California Ridge Wind Farm Champaign County, IL

Natural Resource Report

October 6, 2011

California Ridge Wind Farm Natural Resource Report Summary

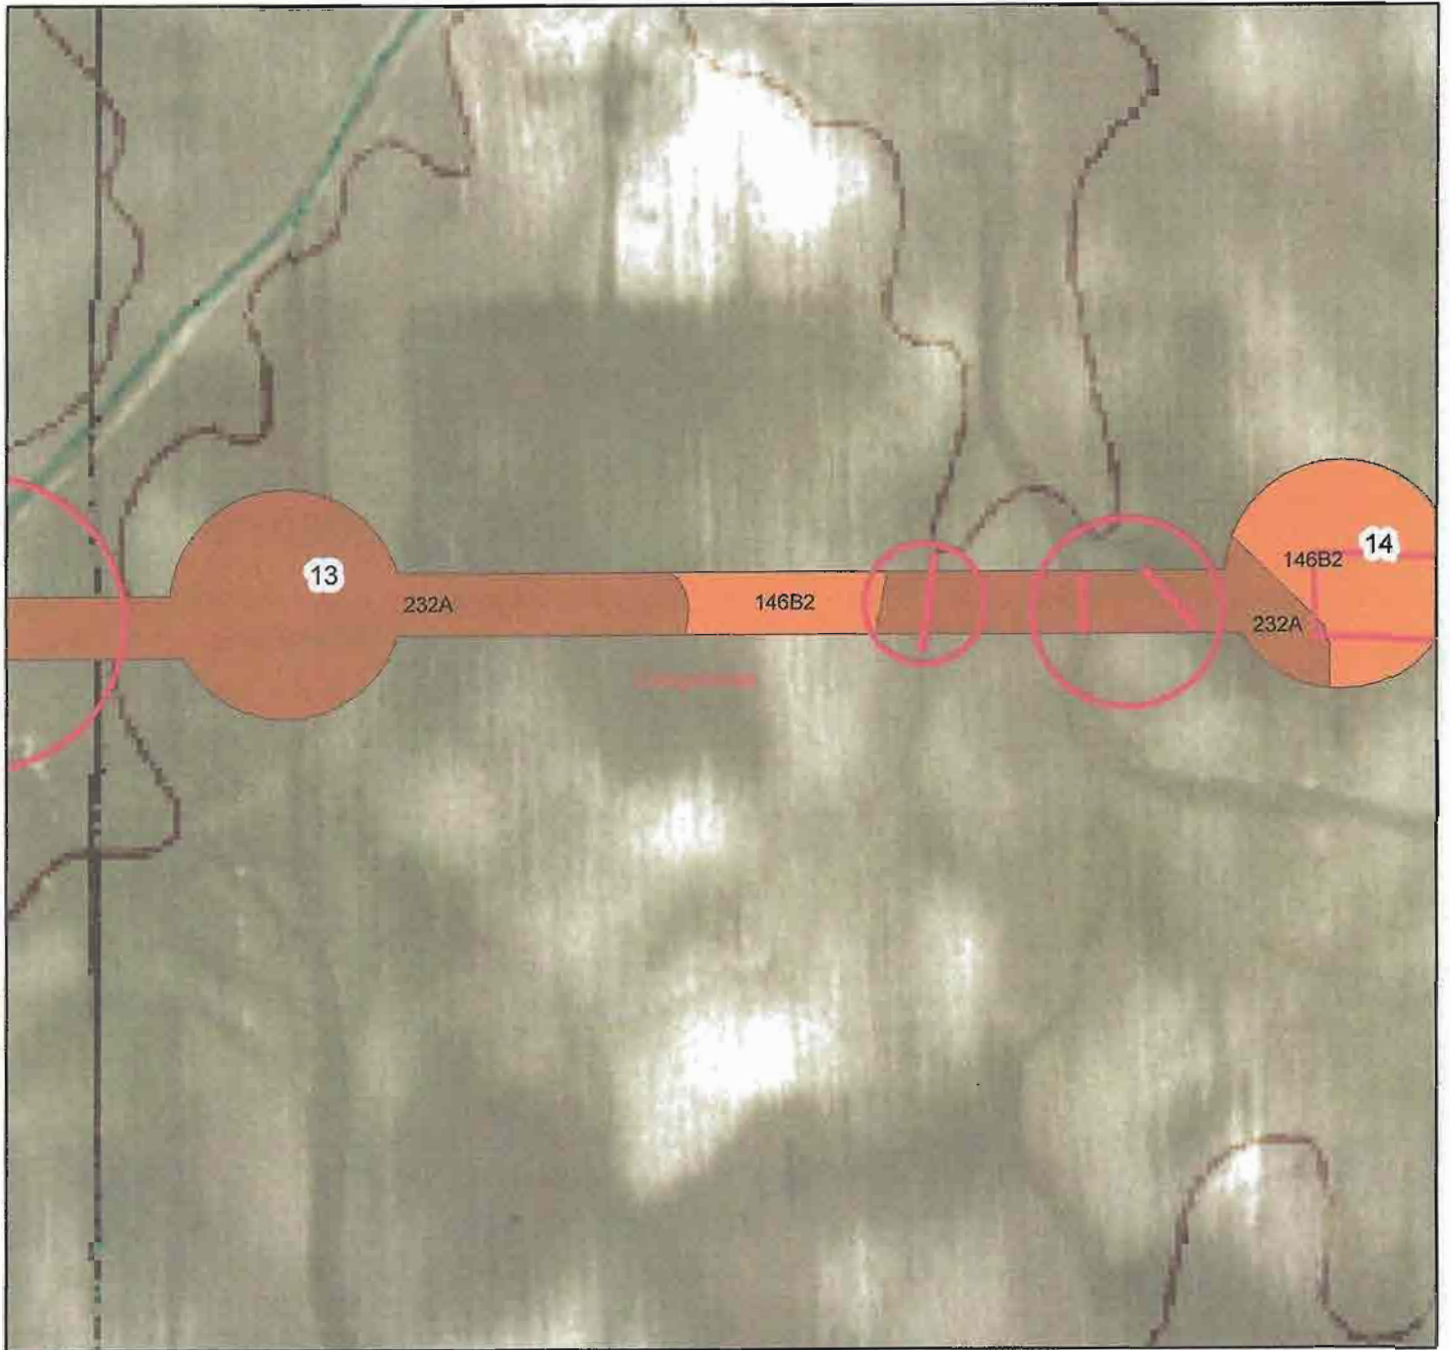
The 146B2 (Elliott Silty Clay Loam) soil has a 2-4% slope that could be an issue with water flowing over the access road possibly causing erosion of the road surface or depositing silt on the access road. This is only a minor concern at this site because the area of this soil type is short.

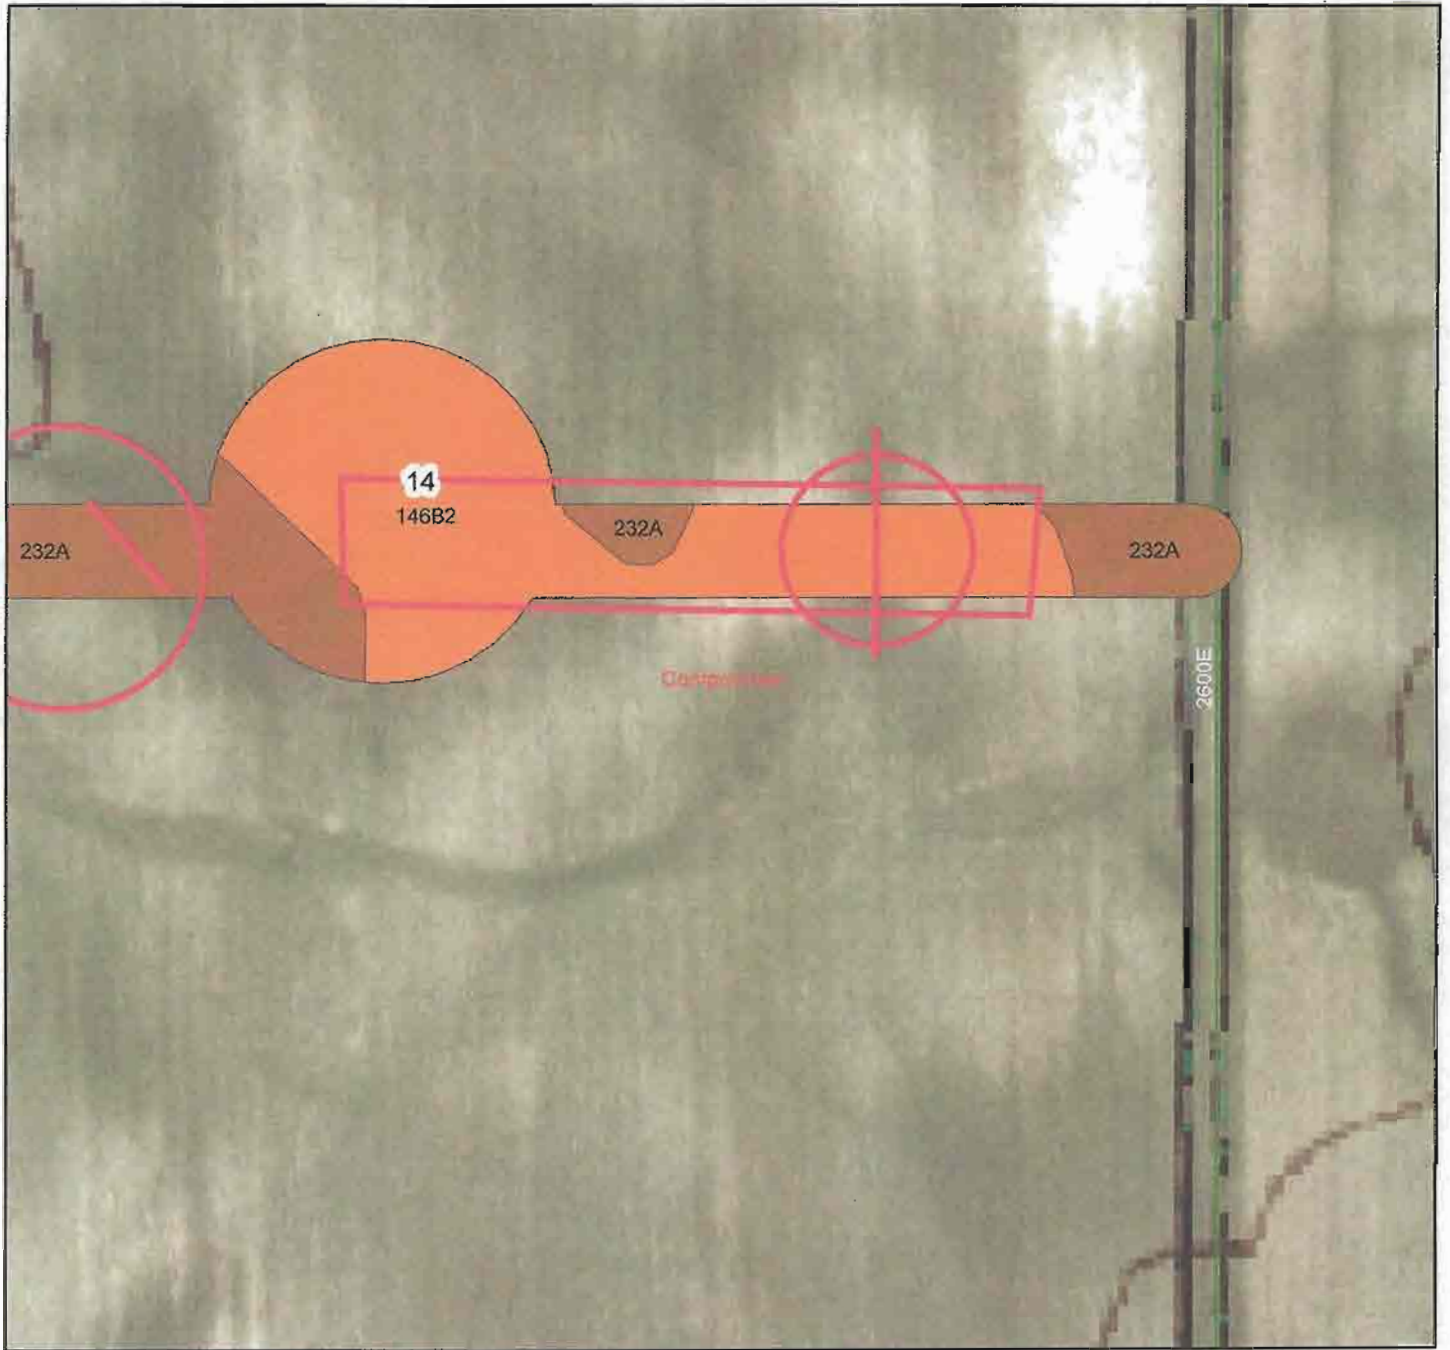
The 146B2 (Elliott Silty Clay Loam) soil has a 2-4% slope that could be an issue with water flowing over the access road possibly causing erosion of the road surface or depositing silt on the access road. The area most susceptible is outlined in a red rectangle.

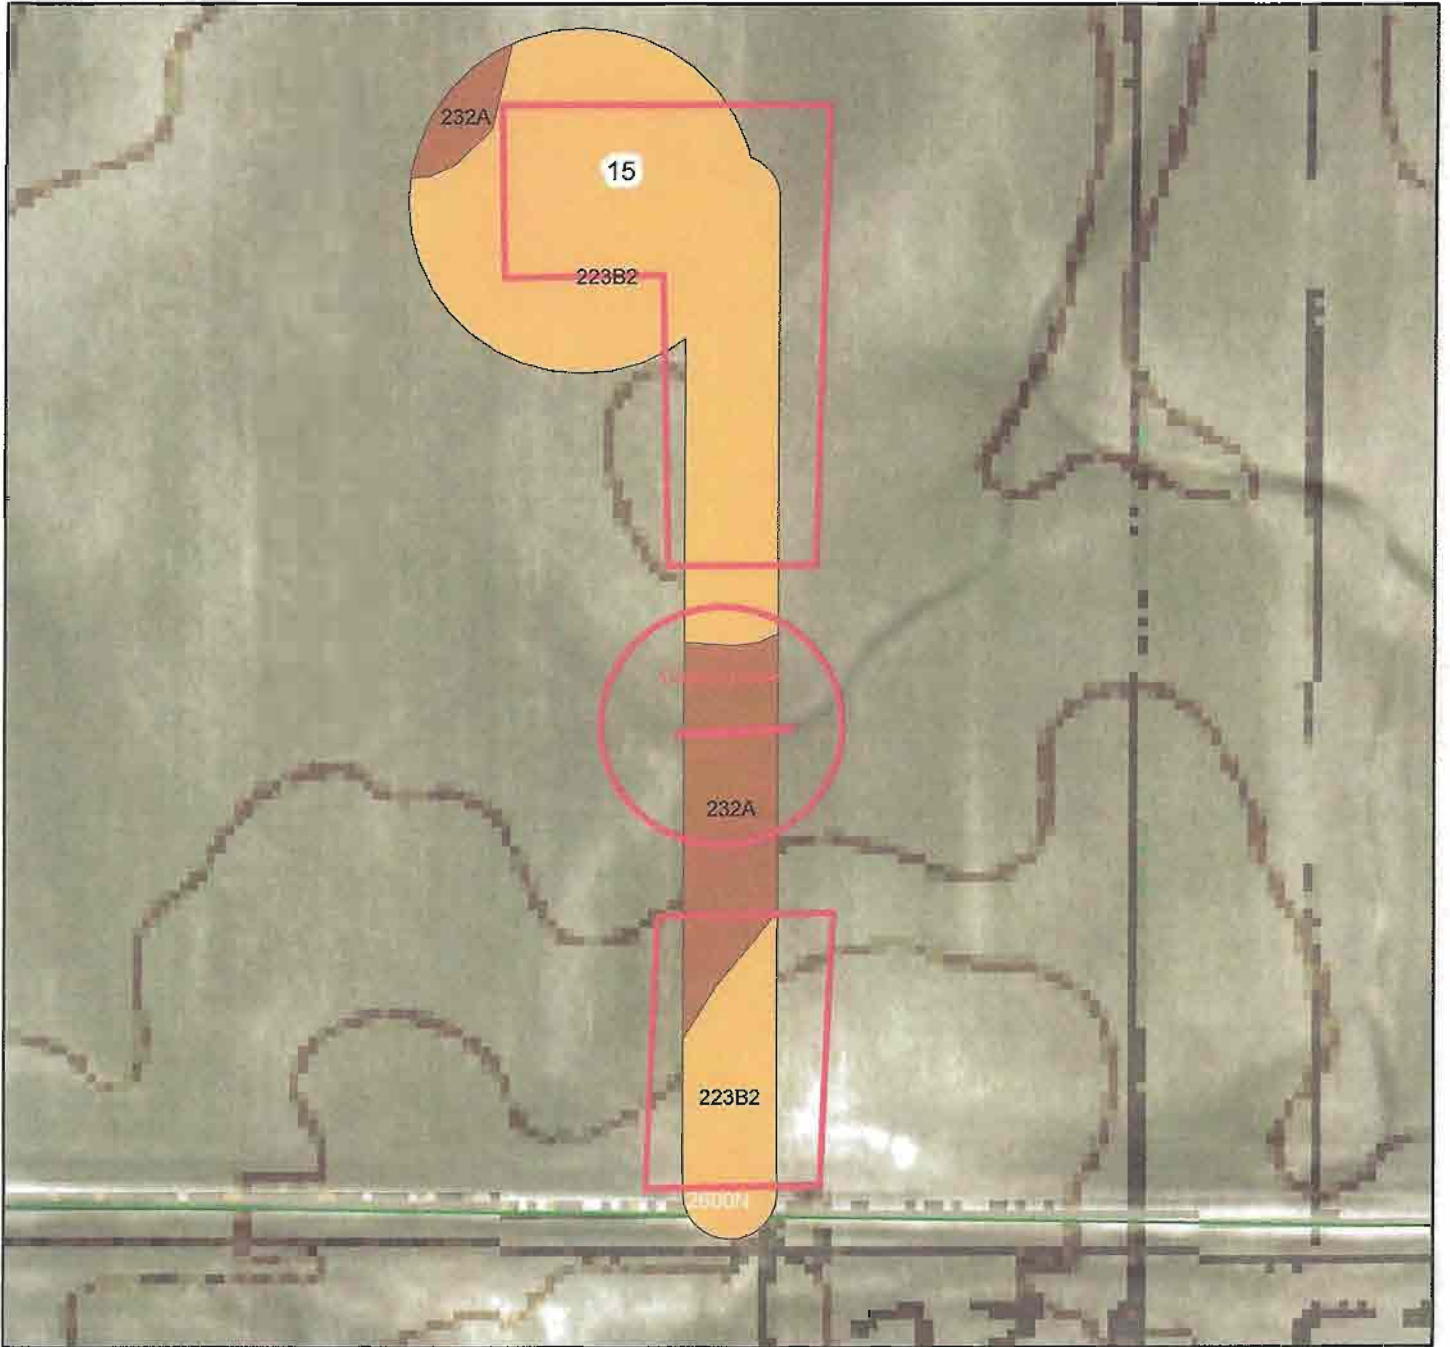
The 223B2 (Varna Silt Loam) soil has 2-4% slopes that could be an issue with water flowing over the access road possibly causing erosion of the road surface or depositing silt on the access road and turbine parking area. The area most susceptible is outlined in red rectangles.

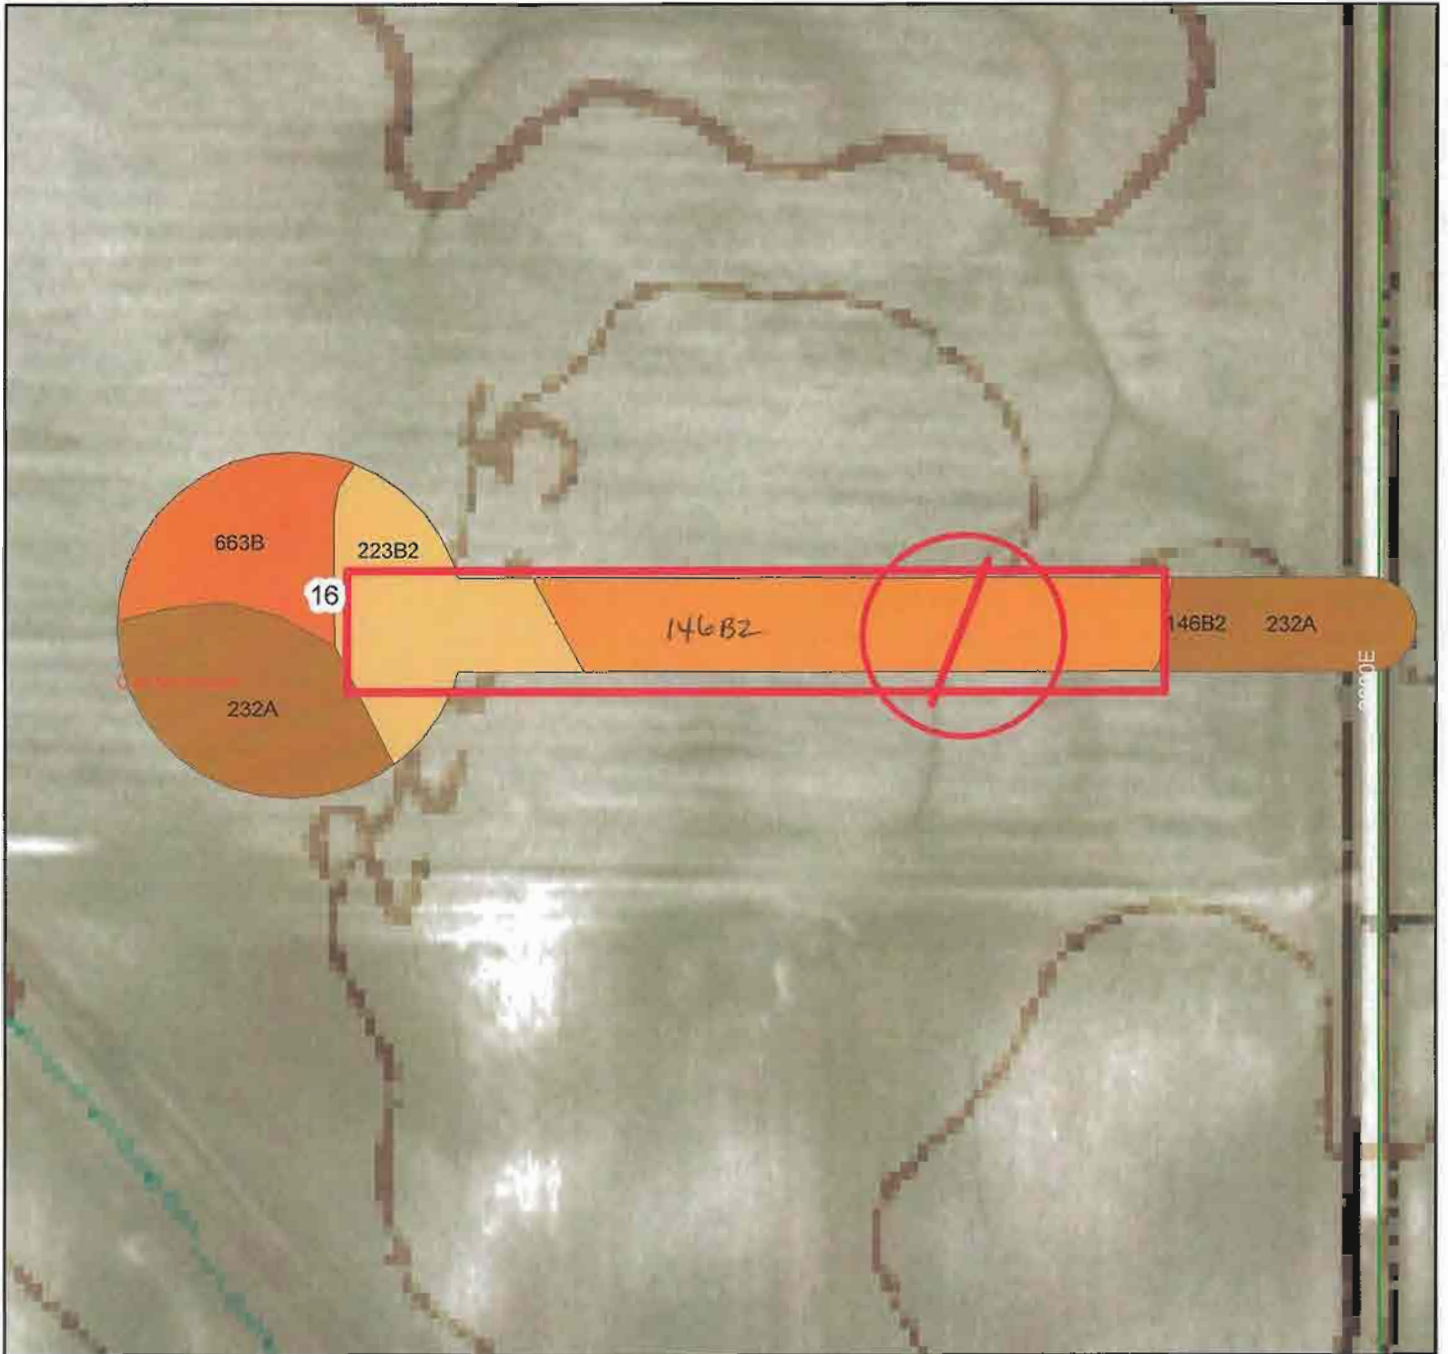
The 223B2 (Varna Silt Loam) soil has 2-4% slopes that could be an issue with water flowing over the access road possibly causing erosion of the road surface or depositing silt on the access road and turbine parking area.

There is some 663B (Clair) soil that has 2-5% slopes that may also be an issue, but it starts at the edge of the site and slopes away from the turbine.

The area most susceptible is outlined in a red rectangle.

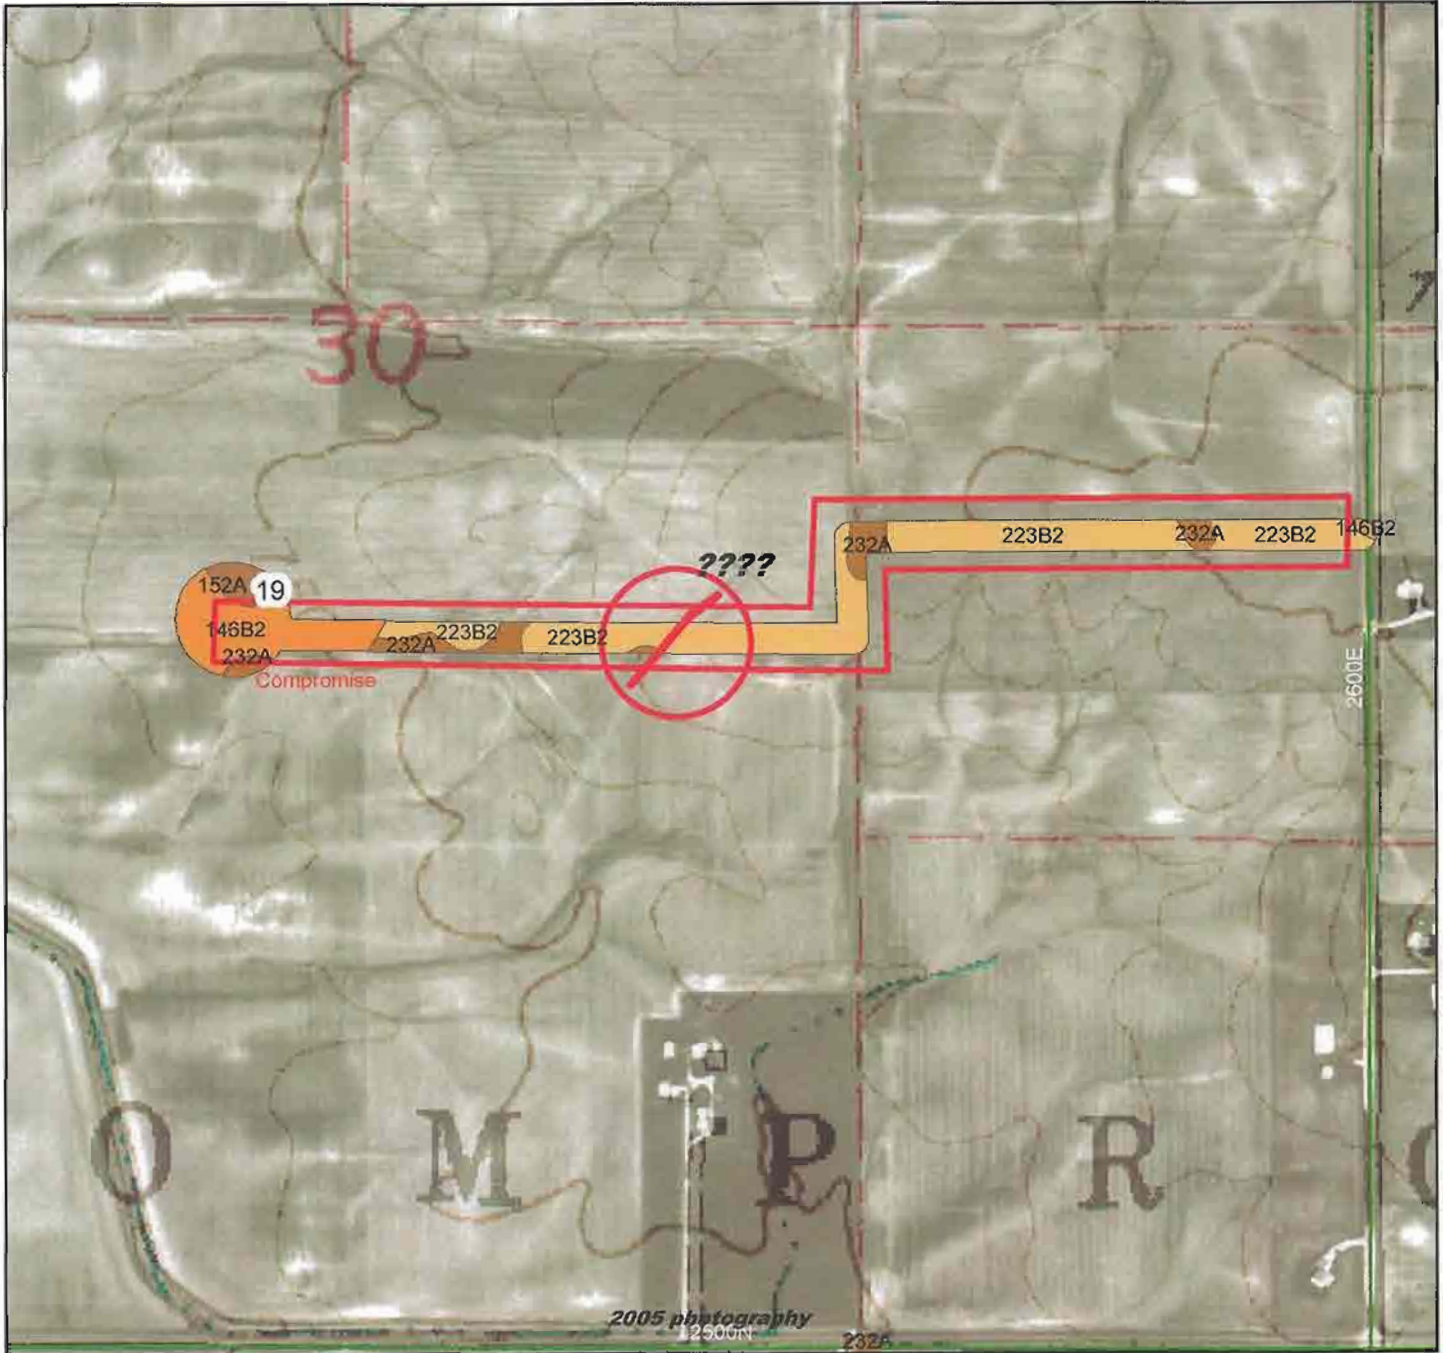
The 146B2 (Elliott Silty Clay Loam) soil has a 2-4% slope that could be an issue with water flowing over the access road possibly causing erosion of the road surface or depositing silt on the access road and turbine parking area.

The 223B2 (Varna Silt Loam) soil has 2-4% slopes that could be an issue with water flowing over the access road possibly causing erosion of the road surface or depositing silt on the access road.

Due to the length of slopes at this site erosion along the edges of the access road some gulley erosion is possible.

The area most susceptible is outlined in a red rectangle.
